Economic Commission for Europe**Inland Transport Committee****World Forum for Harmonization of Vehicle Regulations****Working Party on General Safety Provisions****108th session**

Regulation No. 58 (Rear underrun protection)**Proposal for the 03 series of amendments to Regulation No. 58
(Rear underrun protection)****Submitted by the expert from Germany ***

Figure 1

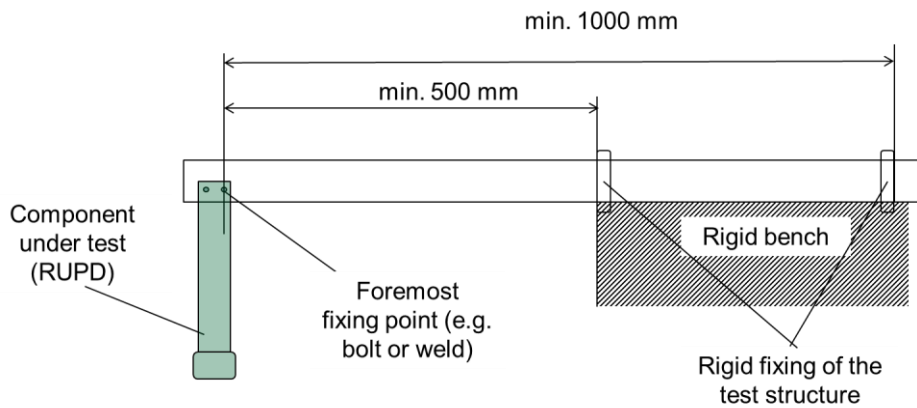
Paragraph 1.2., amend to read (including a new Figure 1):

"1.2. In the case of paragraphs 1.1.2., ~~and 1.1.3~~ the parts of the vehicle chassis ~~or to the rigid test bench~~ shall be on the vehicle. **The part of**

the chassis can be fixed on a test bench as shown in Figure 1, representing the minimum requirements to be fulfilled. The structures used as side rails shall be representative of the chassis of vehicles for which the underrun protection system is intended.

The distance of the foremost fixing point of the RUPD from the rigid test bench shall not be less than 500 mm. If a diagonal strut is used to support the RUPD, this distance shall be measured between the foremost fixing point of the strut to the side rail structures and the rigid test bench.
